ITEM: Case No. PUD-000502-2024 and SRU-000521-2024

LOCATION: 947 Pine Street

REQUEST: Approval of Resolution 9, Series 2024, recommending approval of request for a Planned Unit Development (PUD) Amendment and Special Review Use to allow a bar and restaurant with outdoor dining and miniature golf.

Site plan

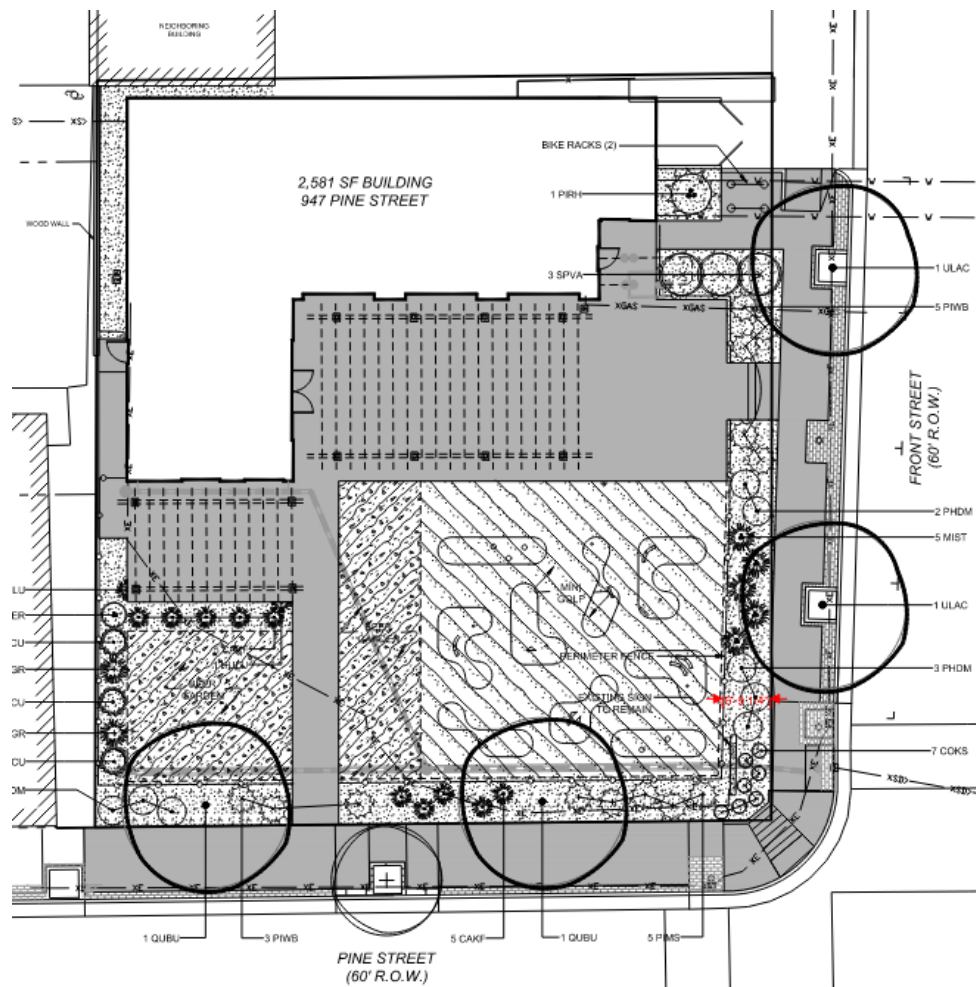
The subject property is a corner lot with frontage on both Pine Street and Front Street which holds a prominent location near a highly trafficked entry point to Downtown Louisville. The proposed addition on the west side of the site will bring the building closer to Pine Street with activated exterior space proposed behind the public sidewalks on both street-adjacent sides of the site. Pergolas are proposed on the south side of the buildings which will provide additional visual interest and further activate the exterior space, according to the applicant. A low, decorative, open-style fence will be installed within a six – seven-foot landscape buffer around the site which the applicant has designed to define the edge of the pedestrian way.

Current conditions on site include two vehicle curb cuts on Pine Street, and a vehicle curb cut and five head-in parking spaces on Front Street. The parking spaces on Front Street are configured such that existing vehicles would back out over the sidewalk and into the street right-of-way, which would not be permitted under currently adopted standards. When combined with the curb cut, the total length of vehicular access points is roughly 84 feet of a 105-foot property line on Front Street, and roughly 50 feet of 95-foot property line on Pine Street. Twelve parking spaces are currently present on site.

Site rendering

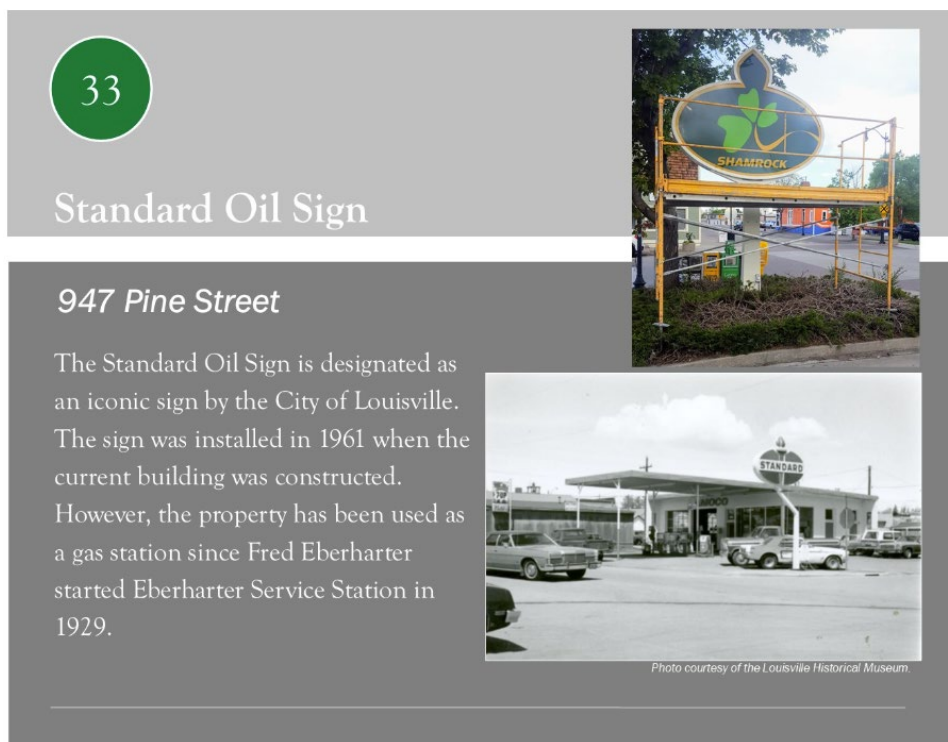
The closure of vehicle access points on the site will permit the construction of full-width, unimpeded sidewalks that will match existing public improvements in the direct vicinity of the site. Additional streetlights and street trees will be installed on both Pine Street and Front Street, and seven to eight new on-street, public parking spaces will be provided directly adjacent to the site.

Proposed additions – waiver exhibit

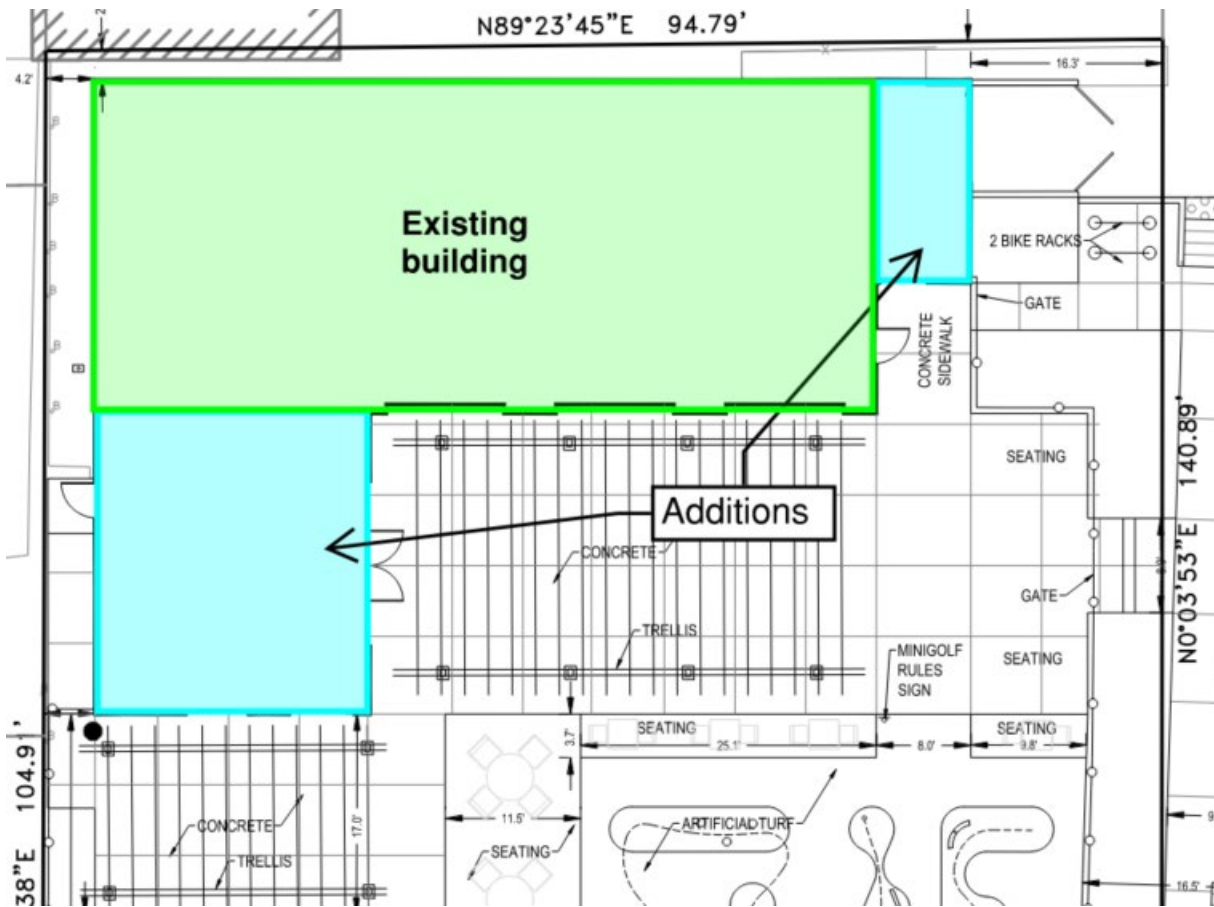
The first waiver seeks relief from the 20-foot rear setback requirement along the north side property line. The existing building is setback 2.5 feet on the north side, and the applicant plans to extend the building by 8.3 feet while retaining the existing setback.

The second waiver requests relief from the 10-foot side interior setback on the west side of the site. The existing setback is 4.3 feet, and the applicant intends to extend the building by 28 feet while retaining the current setback.

Staff find that the side interior and rear setbacks applicable to the C-C zoning district are limiting for this corner property in Downtown Louisville. Existing and historic development patterns in the core area of downtown include conditions with minimal side and rear setbacks, which support the traditional development context present.

The requested waivers will allow for the adaptive reuse of the existing building while retaining a large portion of the site as functional and activated open space. Adjacent property impacts are anticipated to be limited as the applicant is continuing an existing condition on site. Staff recommend approval of the waivers as requested.
